**BOARD OF ZONING APPEALS DIVISION II**

**Case Number:** 2025-DV2-004  
**Address:** 2328 North Harding Street (approximate address)  
**Location:** Center Township, Council District #12  
**Zoning:** D-5 (W-5)  
**Petitioner:** Stonecroft LLC, by Joseph Lese  
**Request:** Variance of Development Standards of the Consolidated Zoning and Subdivision Ordinance to provide for the construction of a detached garage with one-foot side yard setbacks (five feet required) on a lot with an existing duplex.

**Staff Recommendation:** Staff recommends denial of this petition.

2 PROPOSED SITE PLAN  
 1" = 10'-0"

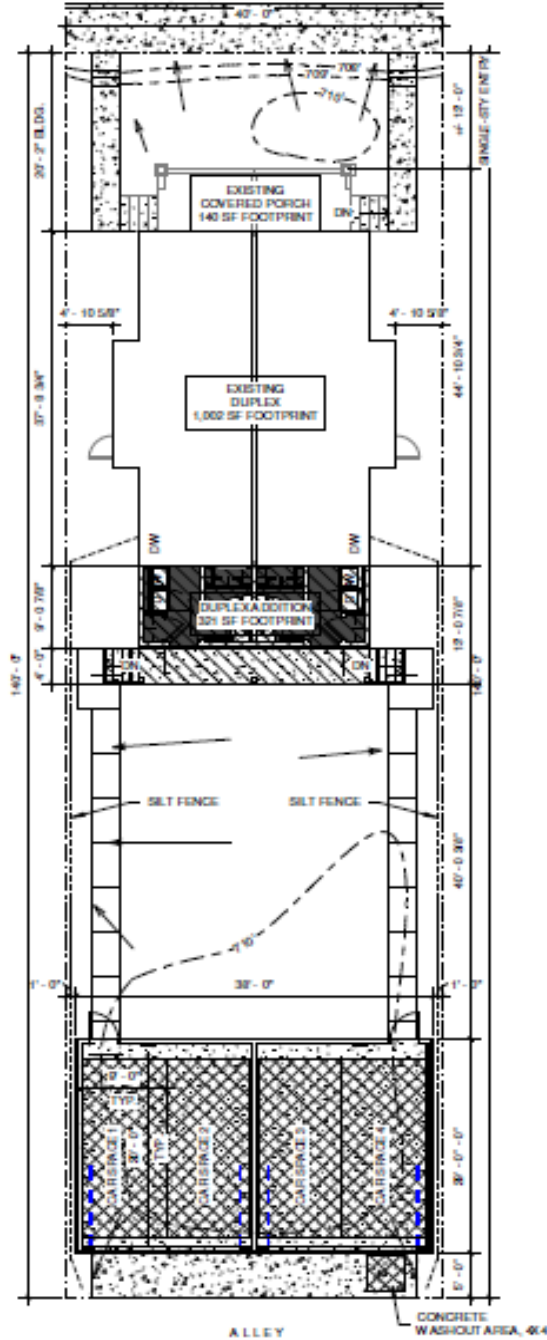
- ◇ The request would provide for the construction of a detached garage with one foot north and south side yard setbacks, where five-foot setbacks are required.

- ◇ There is no practical difficulty associated with the subject site that would warrant the grant of this variance. The subject site has no natural or manmade physical obstacles that would prohibit compliance with the required setback as the proposed detached garage would be new construction and could be designed to meet the required setback without compromising safety or functionality, or negatively impacting adjoining property owners.

- ◇ Any practical difficulty related to the requested reduced setback would be self-imposed by the need to provide two on-site garage parking spaces for each unit, where only one on-site parking space is required for each unit.

- ◇ With the proposed garage at 38 feet in width, each parking space will be limited to nine feet in width, where 10 feet is the standard parking space width size.
- ◇ By providing for the required five-foot side setback, a standard 10-foot wide parking space can still be provided for each unit with an additional five feet for accessory storage in the garage. Or, if two spaces are truly needed, then a 30x38 foot tandem garage can be constructed, and still meet the five-foot required side setback.
- ◇ The request of the one-foot side setbacks for the purpose of providing sufficient off-street parking would be a self-imposed hardship and would negatively impact adjacent property owners. Adjacent properties have demonstrated their ability to be compliant with the Zoning Ordinance and meet the required side setbacks and still provide sufficient off-street parking.
